Bulletin No.: SB-025\_02 Release Date: February 12, 2018 Effective Date: February 12, 2018 Supersedes: SB-025\_00 and SB-025\_01 Completion Date: March 12, 2018

# **Service Bulletin**

Original Ride Manufacturer: Table 1	Affected Production Dates: All
Ride Name: MK12xx sit down series	Affected Serial Nos: Table 1
Model No: -

This Service Bulletin requires additional weld inspections for the MK12xx sit down chassis.

Figure 1 Typical weld location of block connected to chassis with overlapping profile

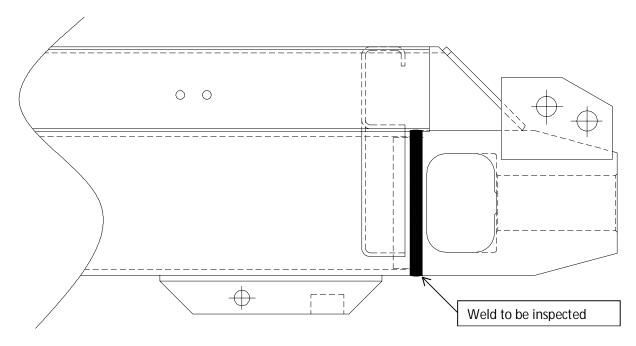
The typical weld details for MK12xx sit down chassis are illustrated in figures 1 and 2.

Perform magnetic testing or dye penetrant testing of all welds as specified in figure 1 and 2 on 100% of the vehicle chassis in the ride system; only required in-case this inspection has not been performed within the last year. NDT examination has to be executed according to the codes as mentioned in table 2. These NDT examinations must be completed before the completion date of this document. If necessary for NDT accessibility, it is required to disassemble the body to access the weld seams.

Perform visual inspection of all welds as specified in figure 1 and 2 on 100% of the vehicle chassis in the ride system. For visual inspection it is not necessary to disassemble any components, only check the welds which are visible without removing components.

1.2.3 Monthly maintenance (corresponds with approximately 2500 ride cycles) Perform Eddy current testing, magnetic testing or dye penetrant testing of all welds as specified in figure 1 and 2 on 100% of the vehicle chassis in the ride system. NDT examinations need to be executed according to the codes as mentioned in table 2. For Eddy current testing, magnetic testing and dye penetrant testing it is not necessary to disassemble any components, only check the welds which are accessible without removing components.
